UNITED STATES PATENT AND TRADEMARK OFFICE

APPLICATION NO.	FILING DATE	FIRST NAMED INVENTOR	ATTORNEY DOCKET NO.	CONFIRMATION NO.
10/527,468	12/22/2005	Oliver Fahnle	1248.001	2190
23598	7590	10/11/2006	EXAMINER	
BOYLE FREDRICKSON NEWHOLM STEIN & GRATZ, S.C. 250 E. WISCONSIN AVENUE SUITE 1030 MILWAUKEE, WI 53202			SCRUGGS, ROBERT J	
			ART UNIT	PAPER NUMBER
			3723

Office Action Summary	Application No. 10/527,468	Applicant(s) FAHNLE, OLIVER	
	Examiner Robert Scruggs	Art Unit 3723

DETAILED ACTION

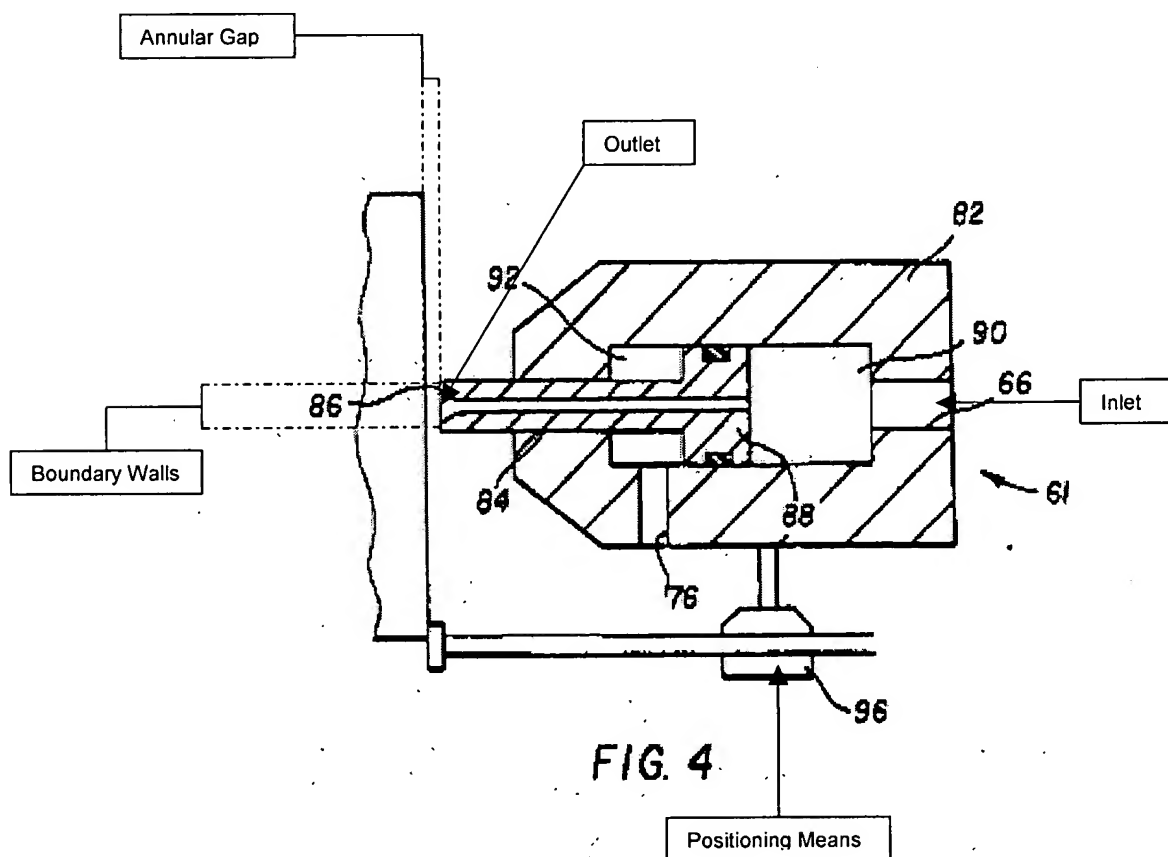
3. Claims 15-33 are rejected under 35 U.S.C. 102(b) as being anticipated by Hashish et al. (5700181). Hashish et al. discloses a device for abrasive machining of surfaces of components comprising, a tool having a cylindrical outer contour with an inlet and an outlet (see figure below) having a circular cross-section, a supply unit (64) for conveying to the inlet a liquid brought under various pressures (which includes pressures being under 20 bar or even 5 bar, see Column 3, Lines 20-25) in which abrasive agents are dissolved and emerged from the outlet, positioning means formed as a control unit (96) as part of the device which guides the tool across a surface to be machined (16) and simultaneously positions (Column 4, Lines 55-60) said tool in such a manner that the outlet faces the surface to be machined such that an area of an annular gap (see figure below) defined by boundary walls (see figure below) of the outlet and the surface to be machined is smaller than a cross-sectional area of the inlet, the cross-sectional area of the inlet being greater by a factor of at least 5 than the cross-sectional area of the annular gap, the height of the annular gap being smaller than 3mm and is

preferably about 1mm (Column 3, Line 62-Column 4, Line 9), since the height of the annular gap can be varied, one could select a height that provides the cross-sectional area of the inlet being greater by a factor of at least 5 than the cross-sectional area of the annular gap and regarding to the outer diameter of the outlet being half of an aperture of an optical component and being conformed to the smallest radius of the optical component, Hashish et al. inherently discloses that the outer diameter of the outlet could be formed by half of an aperture of an optical component and also being conformed to the smallest radius of the optical component depending on the type and size of the optical component selected by a user.
